B26.014 — CUYAMACA COLLEGE AUTO LIFTS REPLACEMENT

ADDENDUM NO. 2

Cuyamaca Community College Building K Auto Lifts Replacement Project

DSA #04-124611 FILE #37-C5 RCA Project No. 1-110-01

BUILDING K NEW AND DEMO FLOOR PLAN

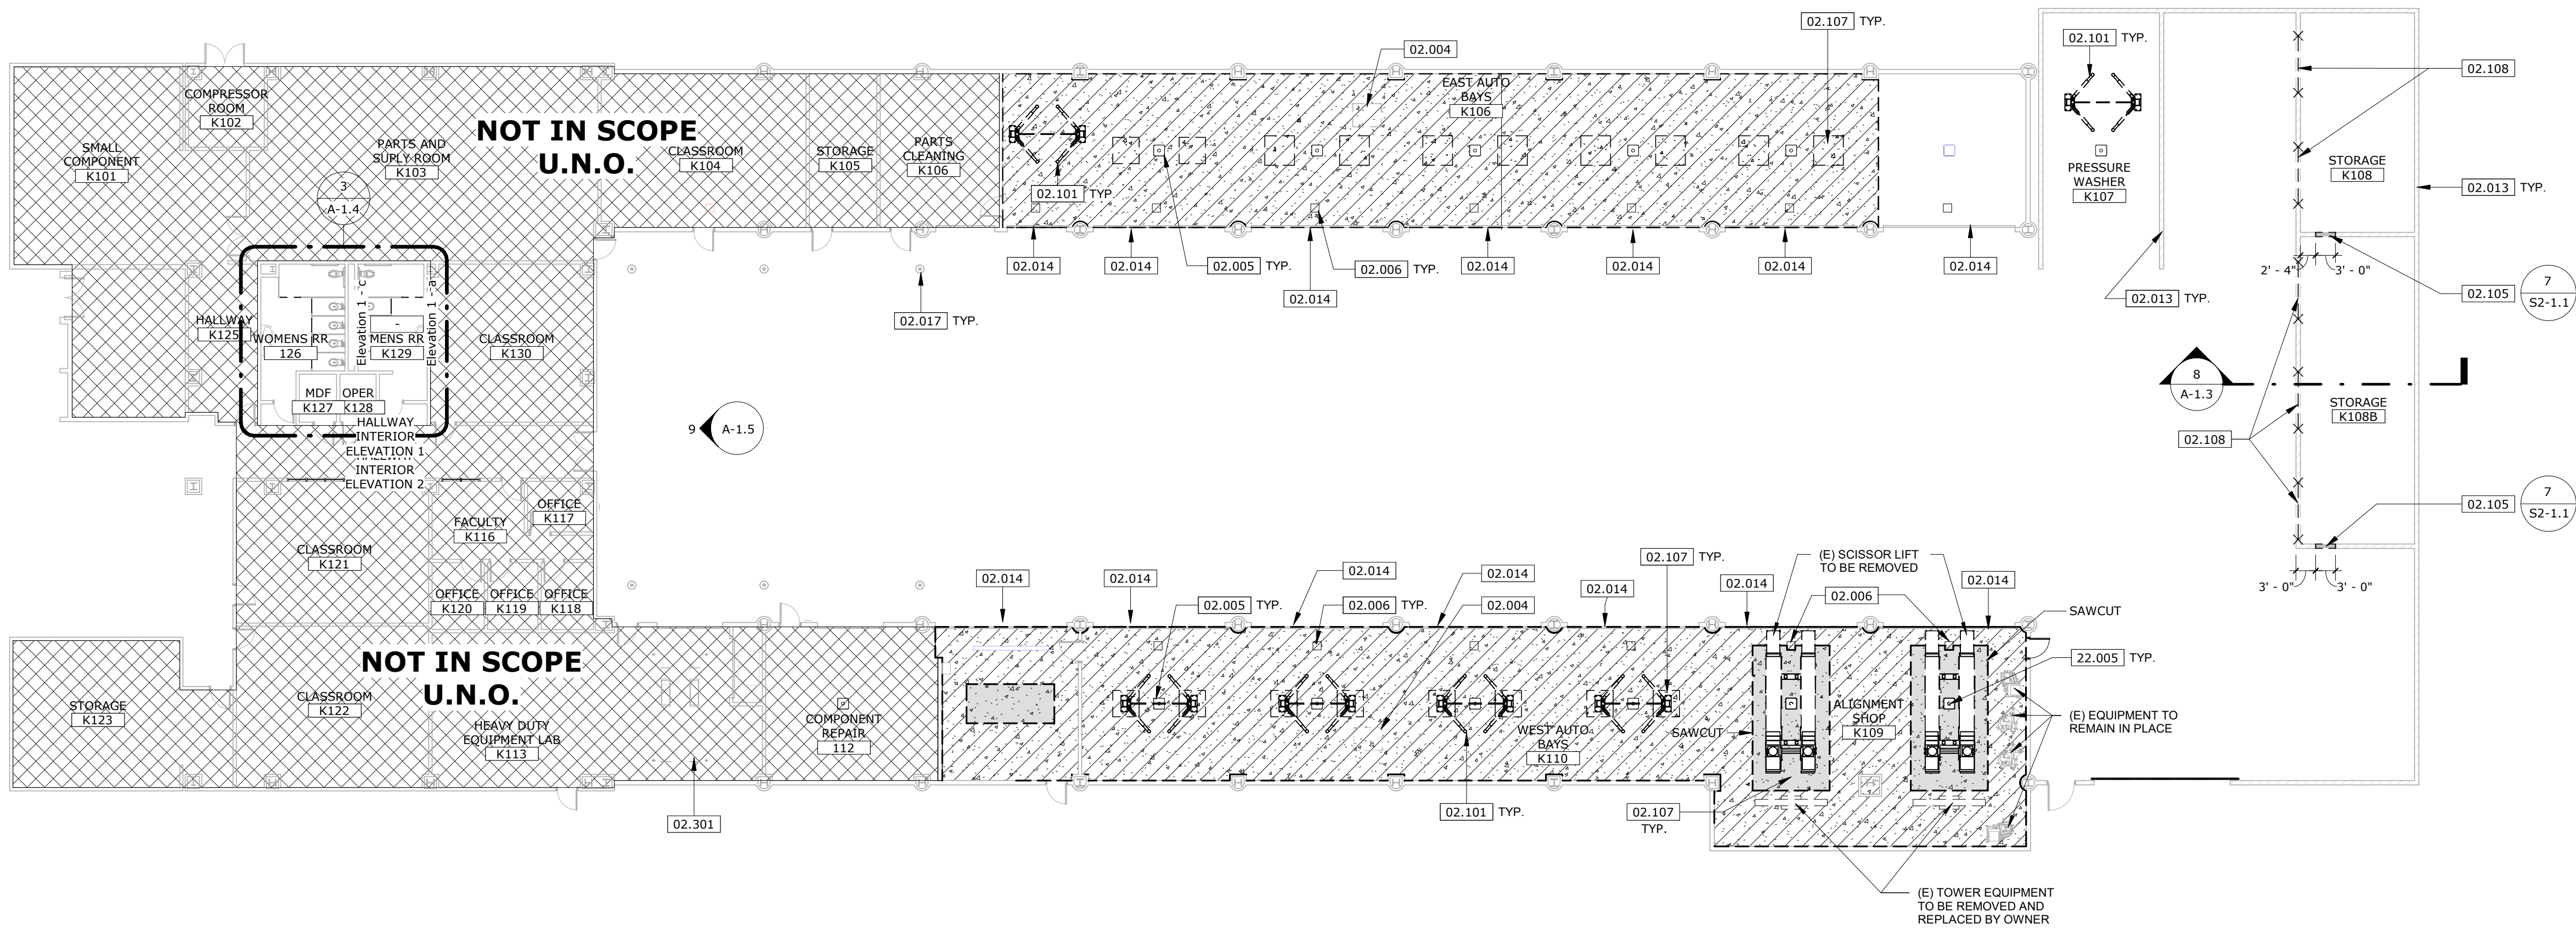
- Item No. 1.5 Reference Sheet A-1.1 – NEW AND DEMO FLOOR PLAN
1.5.1 Revise sheet A-1.1 per clouded areas listed below:
 (a) Revise Legend to update Epoxy flooring basis of design.

EPOXY FLOOR COATING WITH ANTI-SLIP FINISH. CONTRACTOR TO REMOVE (E) FINISH AS REQUIRED PER MANUFACTURER INSTRUCTIONS

BASIS OF DESIGN PRODUCT: ARMORSEAL 1000 HS.
MANUFACTURED BY SHERWIN-WILLIAMS.
SEE SPEC 09 96 00 FOR ADDITIONAL INFORMATION.

BUILDING ELEVATION - SOUTH	SCALE: 3/32" = 1'-0"	1
----------------------------	-------------------------	---

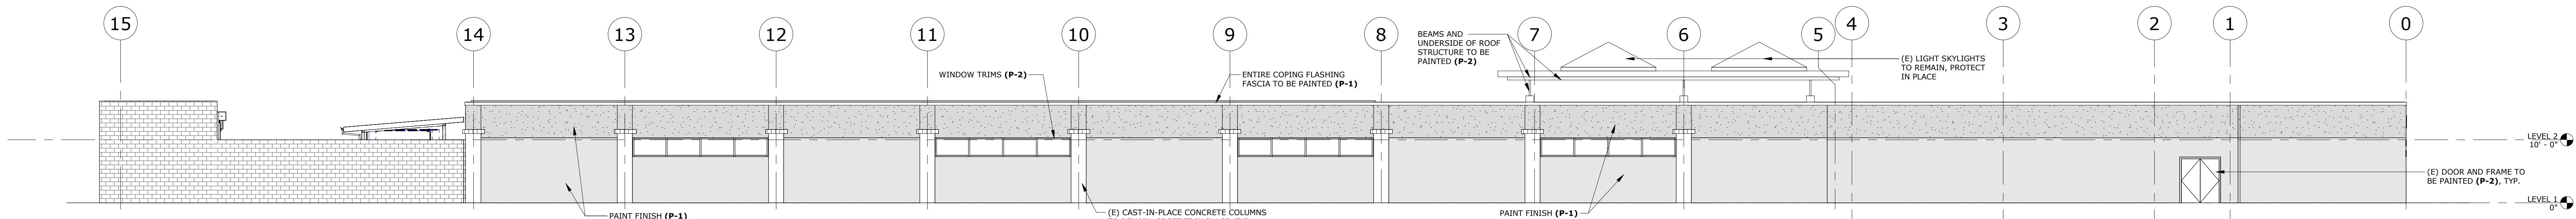
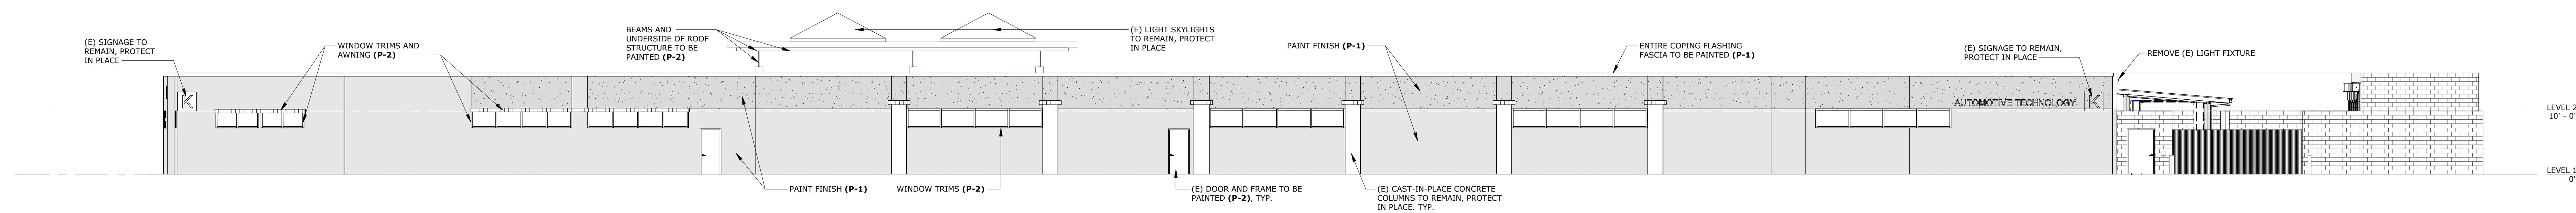
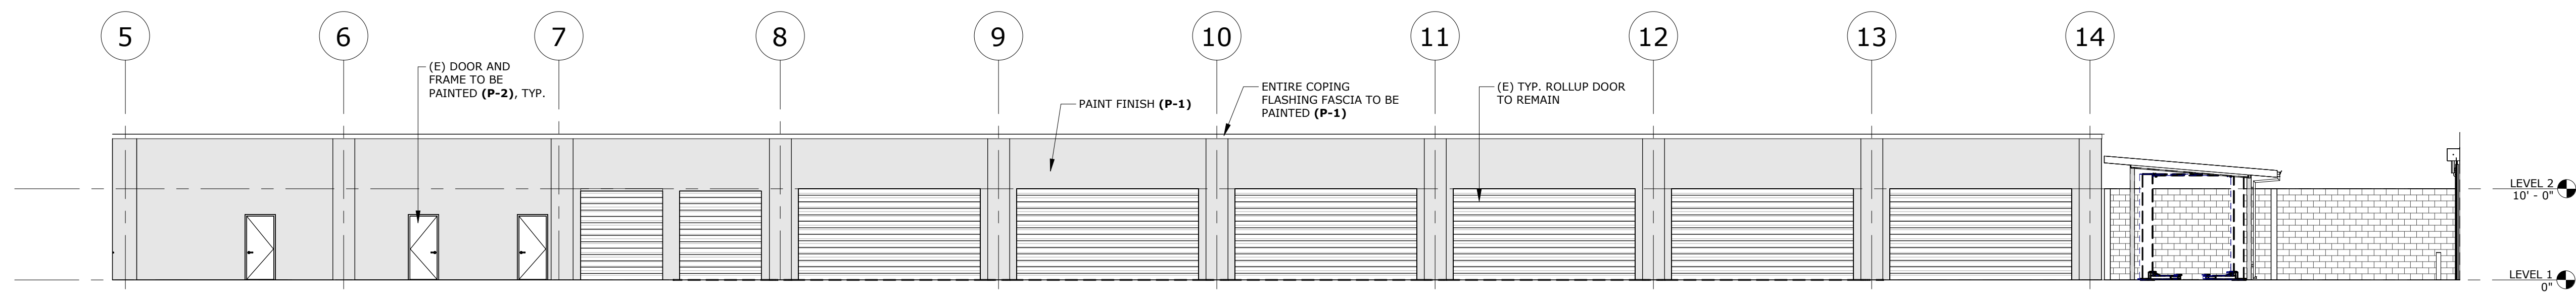
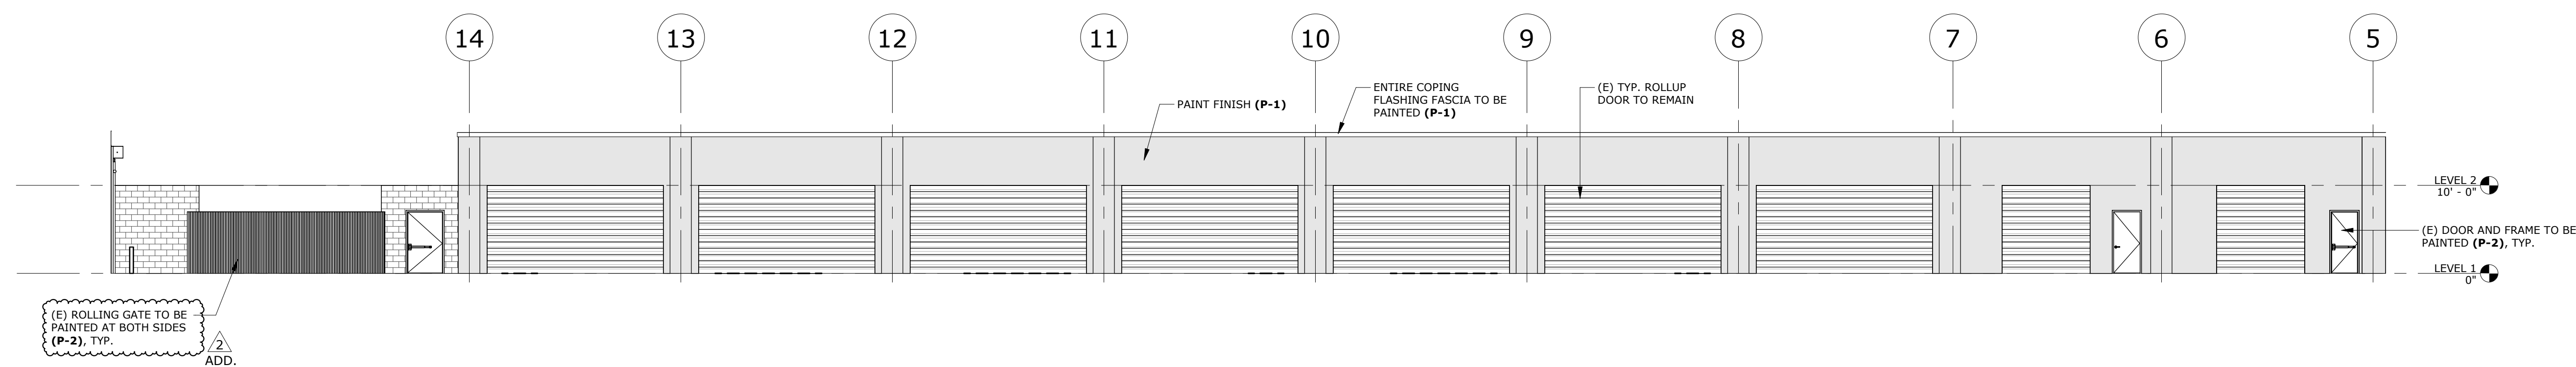
- Item No. 1.6 Reference Sheet A-1.5 – BUILDING ELEVATIONS
1.6.1 Revise sheet A-1.5 per clouded areas listed below:
 (a) Revise Exterior Elevations Legend paint color.

(b) Added note to paint rolling gate for Building Elevation 6.
- Item No. 1.7 Reference Sheet A-1.7 – OVERALL CEILING PLAN
1.7.1 Added new sheet A-1.7 per clouded areas listed below:

PAINT		
	PAINT (P-1) SW6121 WHOLE WHEAT OR SIMILAR	 (E) TILES
	PAINT (P-2) BLUE BEETHOVEN BLUE OR SIMILAR	 (E) CMU WALL
		 2 ADD.

BUILDING K
OVERALL CEILING PLAN

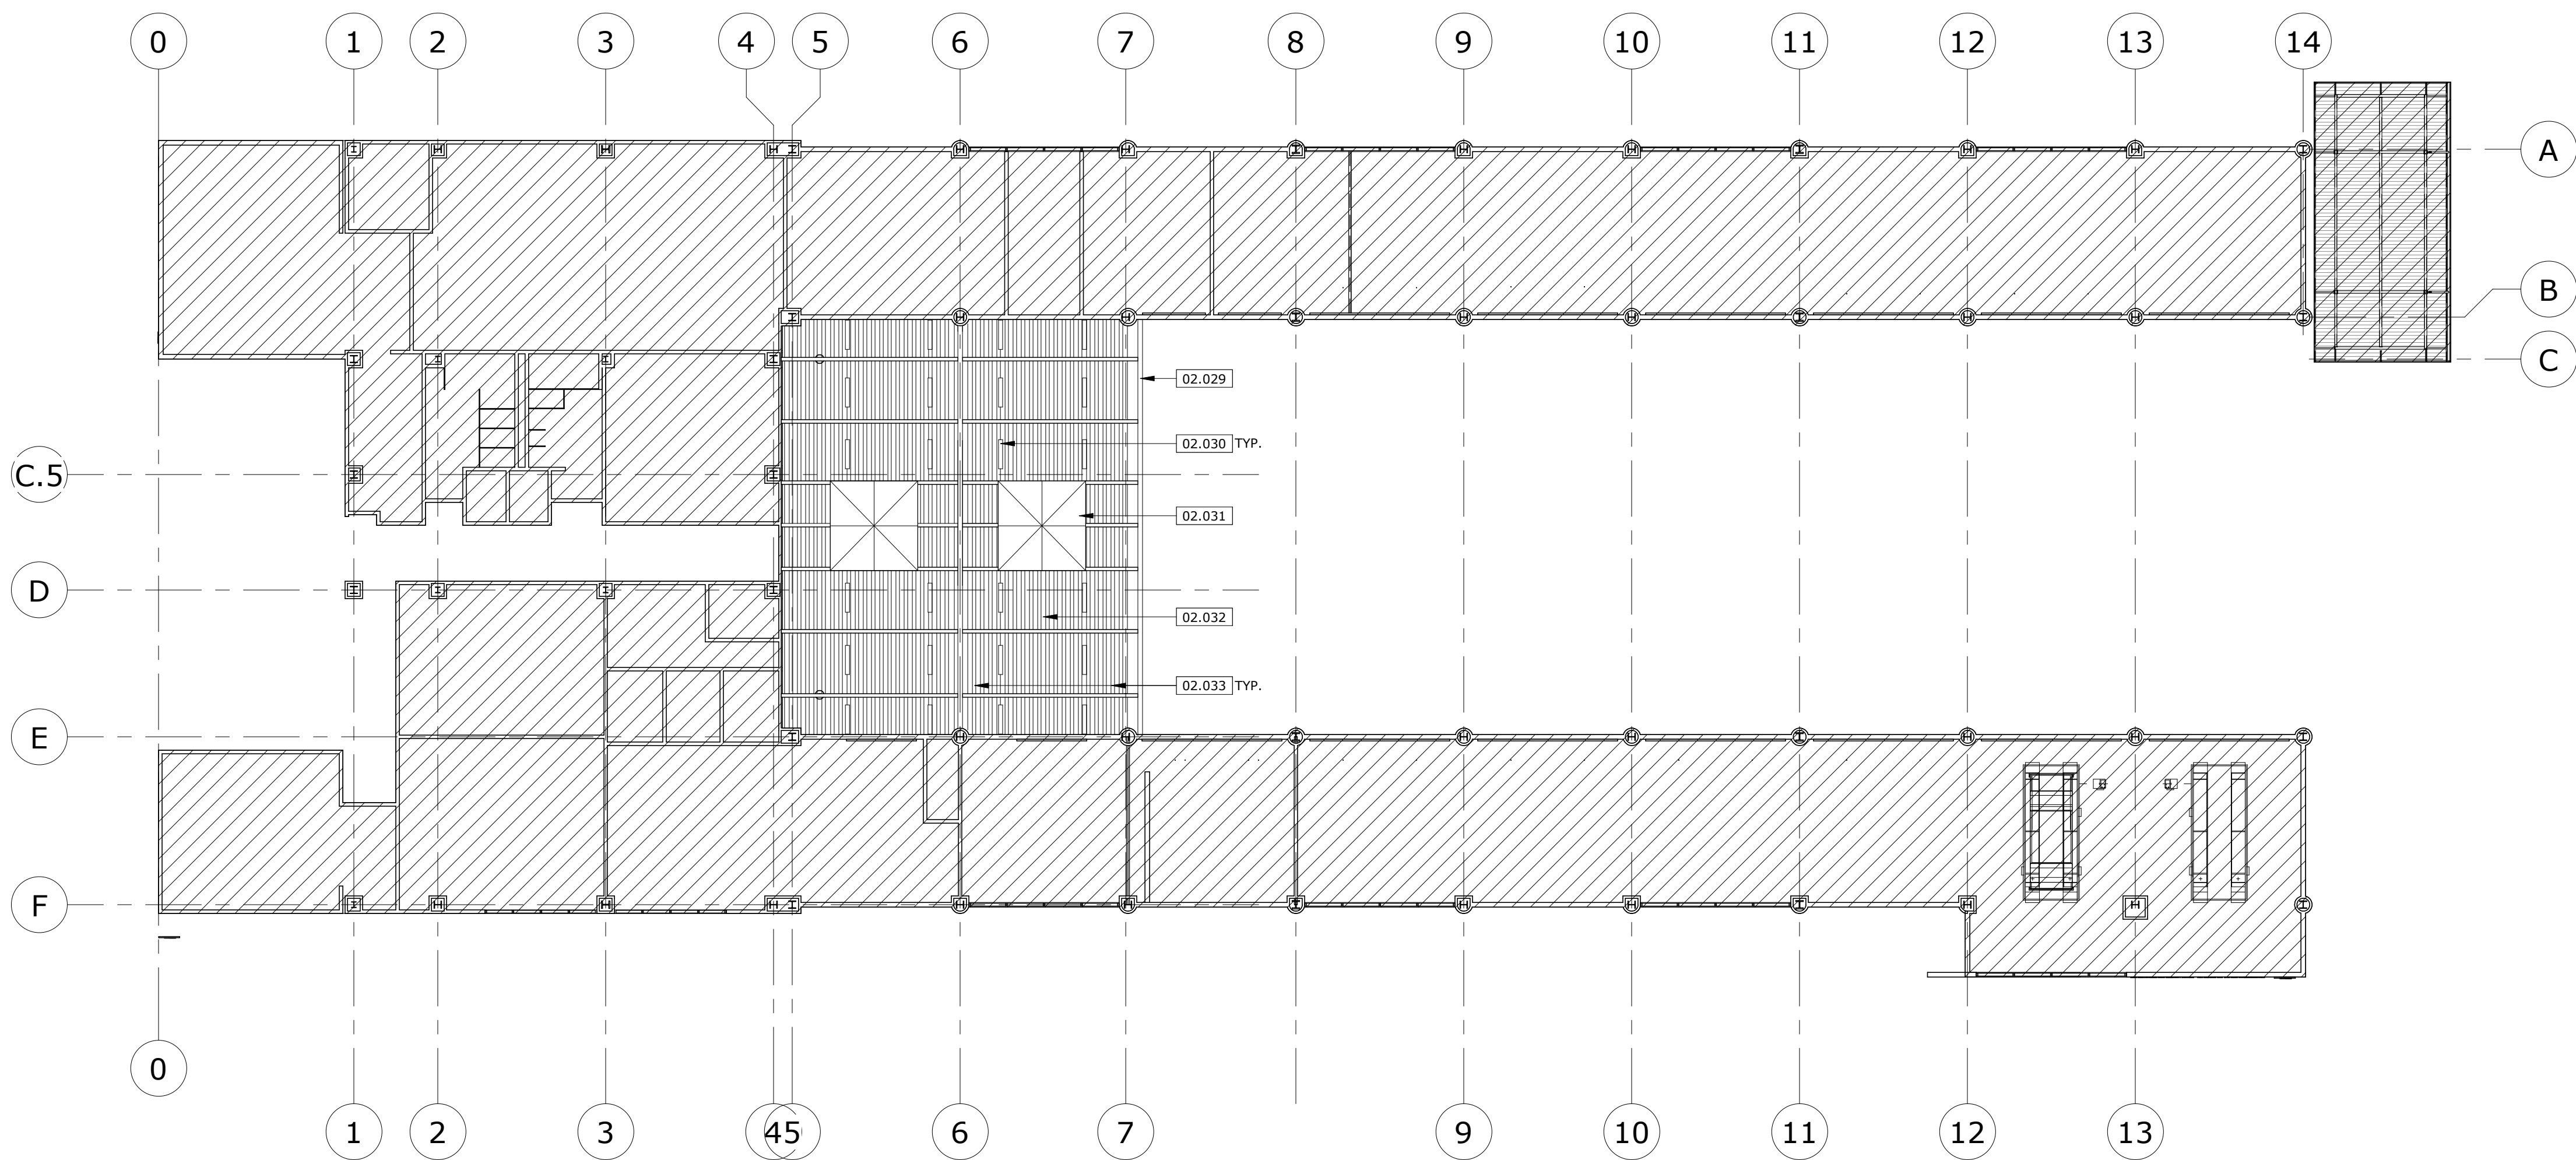
(a) Added detail 1 to indicate new painting of metal roof structure.
- Item No. 1.8 Reference Sheet AD-1 – MISCELLANEOUS DETAILS
1.8.1 Revise sheet AD-1 per clouded areas listed below:
